Mars Stitch Ltd (10053)

15.APRIL.2014

Identified Priority 2 Concerns

1st Priority 2 Concern

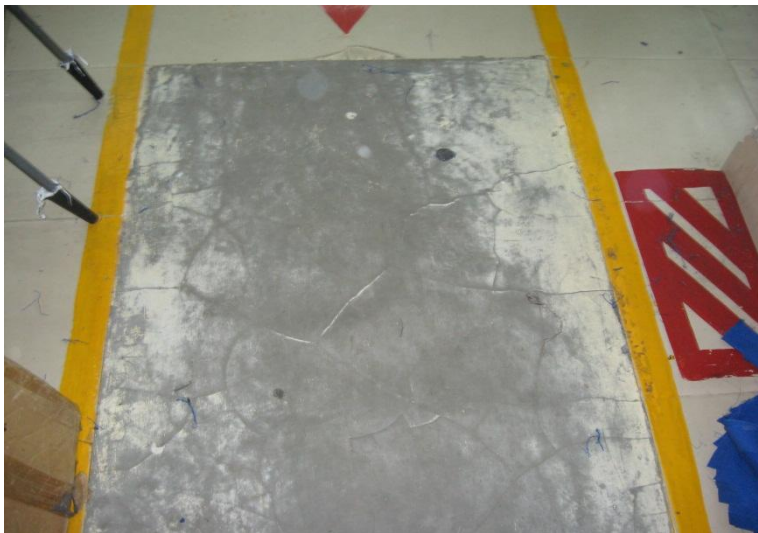
There are cracks in the middle of 2nd floor slabs' soffit in area (E-F/5-6). It also appears that some form of repair has been attempted to cracks on the surface of floor slab above.

- Carry out a Detailed Engineering Assessment of this area .
- The distress found is recommended to be repaired with suitable proper methods. Repair by re-plastering is not suitable.

Additional Comment

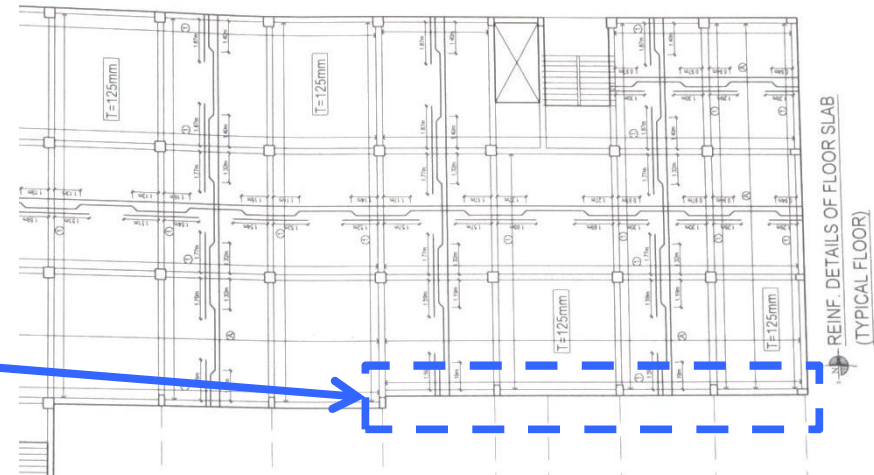
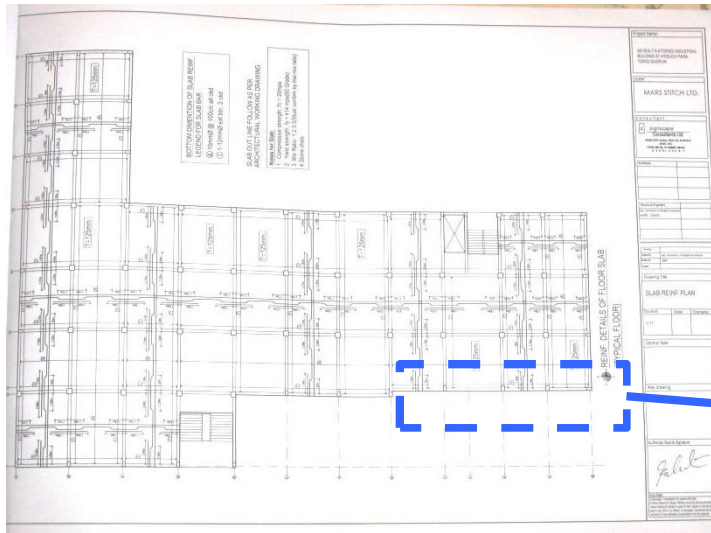
There are signs of crack repairs on the surface of floor slab above, where some finishes have been removed.

Overall stability system / moment frame capacity

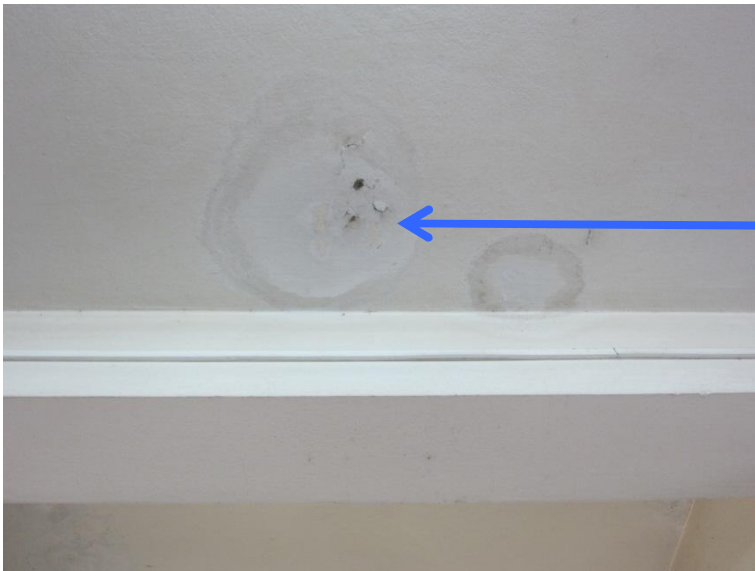
Concerns on the stability system for lateral loading and seismic loading. Façade brickwork walls lack of moment capacity in their connections between columns and beams.

We require that these items be investigated as part of a Detailed Engineering Assessment.

- The Detailed Engineering Assessment of the overall building is to be carried out and in particular, stability and foundation aspects should be investigated in detail.
